STAFF'S  
REQUEST ANALYSIS  
AND  
RECOMMENDATION

06TS0211

Patrick Construction  
Autumn Grove (Formerly Autumn Leaf)

REQUEST: The applicant requests approval of a tentative subdivision plat with seventy-eight (78) lots that requires an exception to Section 17-76 (h) of the Subdivision Ordinance regarding second street access requirements for lots in excess of fifty (50).

### Proposed tentative showing emergency access

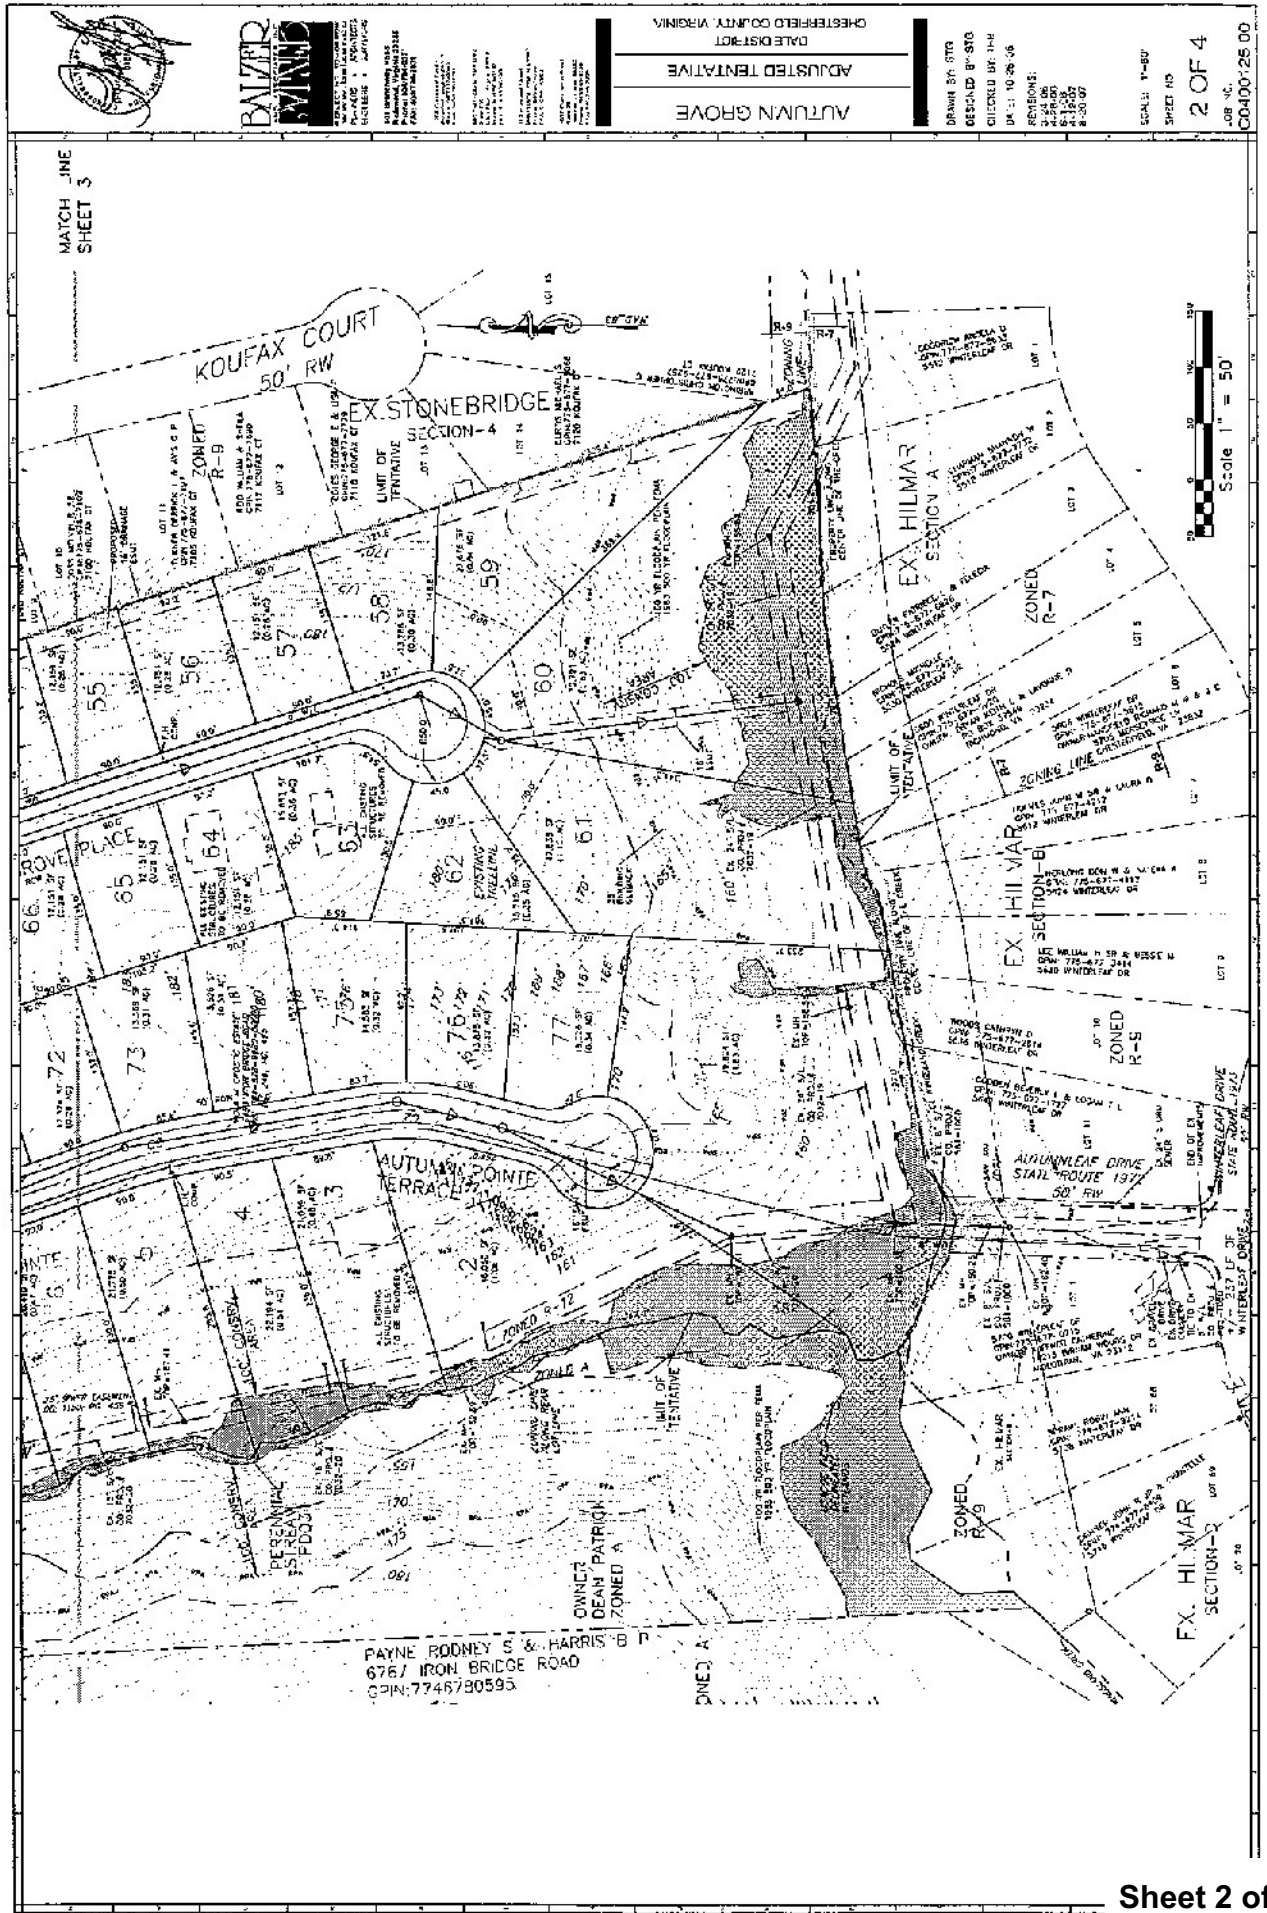
The applicant is proposing two options to provide emergency access, but has provided little surety in the ability or the timing of completing either of these options. The Fire Department has consistently opposed access to more than fifty (50) lots on a single access, unless approved by the Board of Supervisors. For these reasons Staff recommends denial of this request.

If the Planning Commission elects to approve this case, Conditions 2 and 3 provide for the installation of an emergency access prior to the recordation of the twenty-seventh (27<sup>th</sup>) lot in this development as well as the establishment of an HOA to maintain emergency access.

3. Prior to the recordation of the 27th lot within this development, a second access shall be provided to Ironbridge Road or through the Gateline, LLC tract (GPIN 775-679-6282) for the purposes of emergency access. This access shall be designed and installed to a standard accepted by the Fire Department, and approved by the Fire Department. The access shall be gated and its use is prohibited other than during emergency situations. A maintenance agreement requiring maintenance of the access by the Autumn Grove Homeowners Association and identifying by metes and bounds description the exact limits of the maintenance responsibilities of the access shall be provided to the County and the County shall concur with the agreement. The final check and record plat shall bear a note stating "The maintenance and upkeep of the land over which emergency access is granted shall be the responsibility of the Autumn Grove Homeowners Association. Alternatively, the subdivider may provide a second improved access built to VDOT standards. (F, EE, T, P)

Approved tentative with two points of access

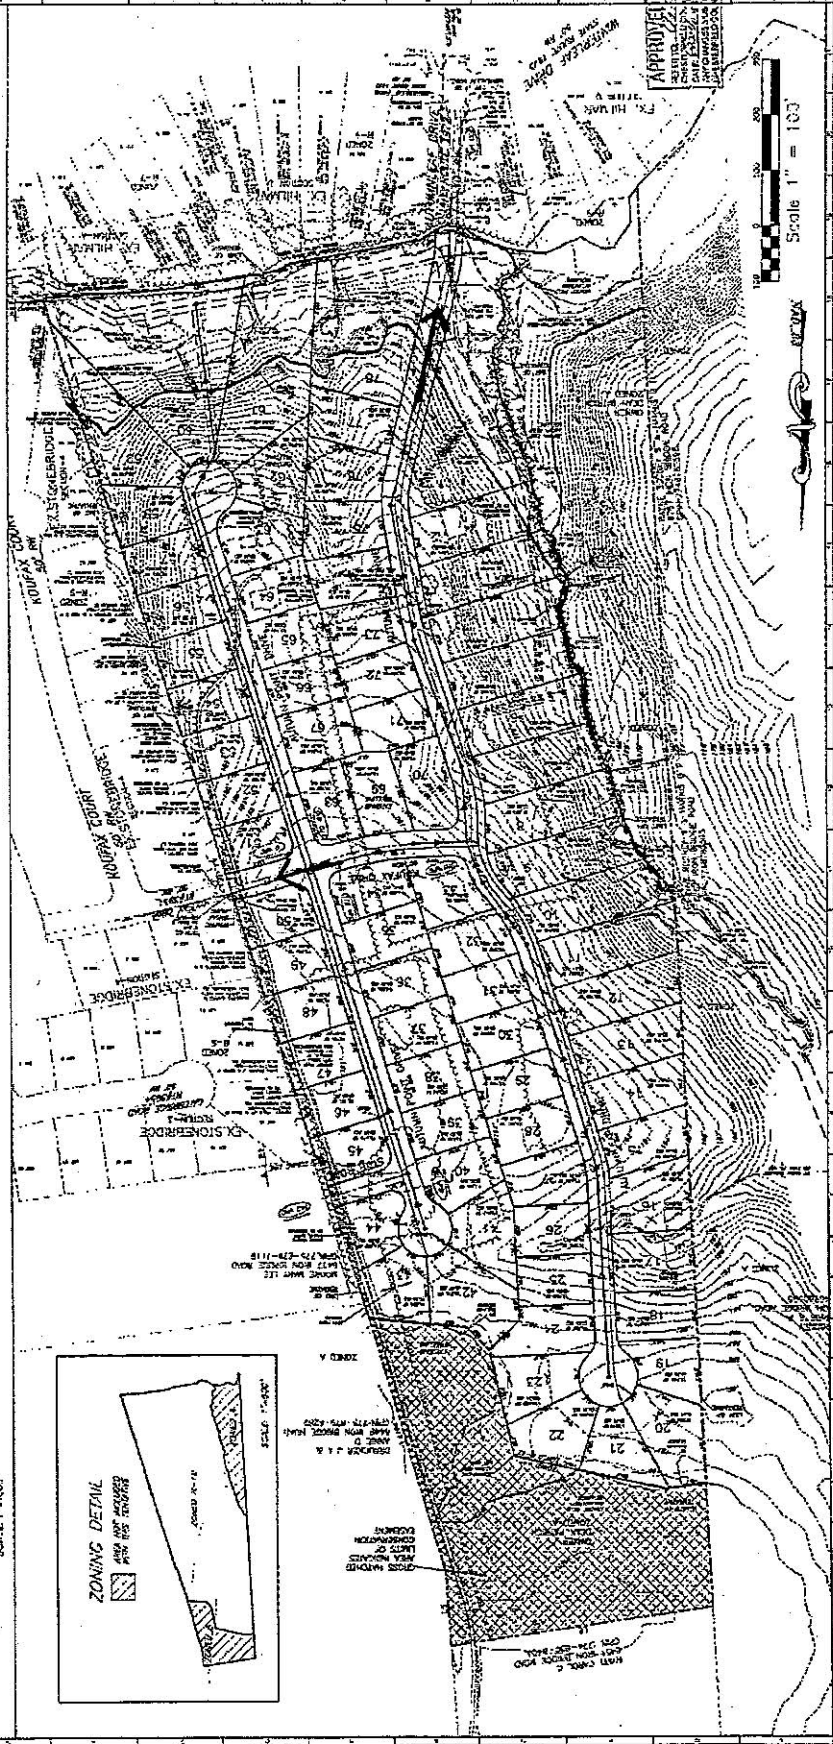
In March of 2007 the applicant met with County Staff to discuss the removal of the Autumn Leaf Drive extension, previously approved as a second access. Staff did not support the request and informed the applicant that the Ordinance provided for a maximum of fifty (50) lots on a local street with one (1) access. Koufax Drive, a local street in the adjacent Stonebridge subdivision serves this development on the eastern line. Since Koufax Drive, already has twenty-four (24) lots recorded from the Stonebridge subdivision, the applicant could record up to twenty-six (26) additional lots within Autumn Grove prior to improving a second access.

Subsequently, the applicant received construction plan approval on June 5, 2007 for the first phase of this development, consisting of twenty-six (26) lots, which depicted road construction for the entire roadway system in this development. However, the second road connection across Kingsland Creek to Autumn Leaf Drive in the Hilmar subdivision was omitted. A condition of the construction plan approval provided for the installation of the second improved access across Kingsland Creek prior to the recordation of the twenty-seventh (27<sup>th</sup>) lot within this development.
